Reference	SSM73417
Models	XJ / X351
Title	Heated rear seats operation is incorrect. 15 model year onwards
Category	Electrical
Last modified	06-Jun-2017 00:00:00
Symptom	208000 Climate Control
Attachments	X351 heated rear seat.pdf (X351 heated rear seat.pdf)

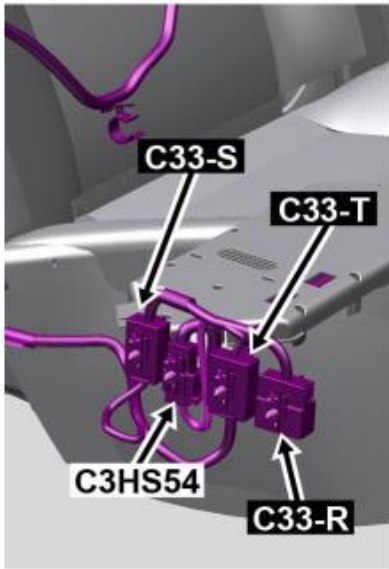
Issue
When the hard keys on the rear seat centre switch pack are operated pressing the Left Hand switch activates the Right Hand seat heater. Pressing the Right Hand switch activates the Left Hand seat heater.

Cause
Incorrect wiring.

Action
Access the connectors on the right hand side of the rear seat. See attachment.
Swap terminal 6 and 9 on connector C33-R using extractor tool 418-595. For further information refer to the electrical library in Topix.

Corrective action on cars built:-
 Swap pins 6 & 9 on connector C33-R located on the right hand side of the rear seat
